**MONTGOMERY COUNTY HISTORIC PRESERVATION COMMISSION**  
**STAFF REPORT**

<b>Address:</b>	7 West Kirke Street, Chevy Chase	<b>Meeting Date:</b>	9/1/2021
<b>Resource:</b>	Contributing Resource (Chevy Chase Village Historic District)	<b>Report Date:</b>	8/25/2021
		<b>Public Notice:</b>	8/18/2021
<b>Applicant:</b>	Marc Katz (Neal Thomson, Agent)	<b>Tax Credit:</b>	N/A
<b>Review:</b>	HAWP	<b>Staff:</b>	Michael Kyne
<b>Permit Number:</b> 963297			
<b>PROPOSAL:</b> Side porch and sunroom removal and construction of new side and rear additions

***Fig. 2: 1927 Sanborn Fire Insurance Map, with the subject property circled in red.***

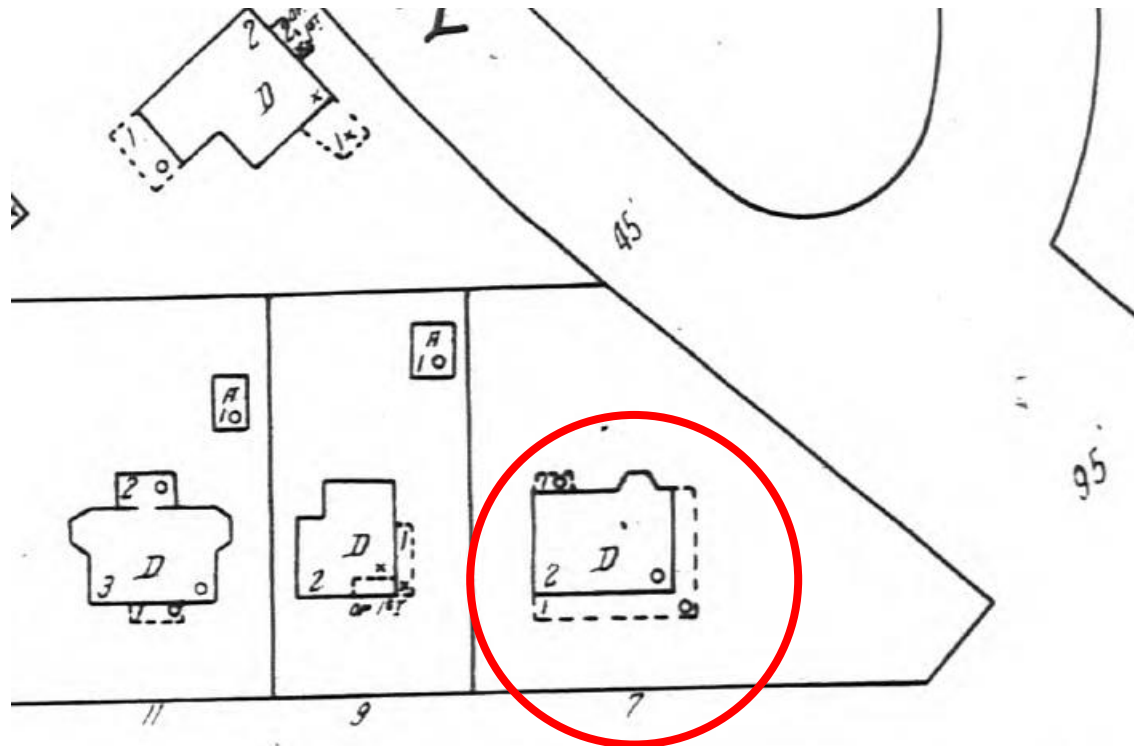
The applicant proposes to remove the existing one-story sunroom with roof balcony and first floor deck at the north side (rear) of the historic house. The sunroom is a non-historic feature, as demonstrated by the June 24, 2009 HAWP approval and 1927 Sanborn Fire Insurance Map (see *Fig.2* above).
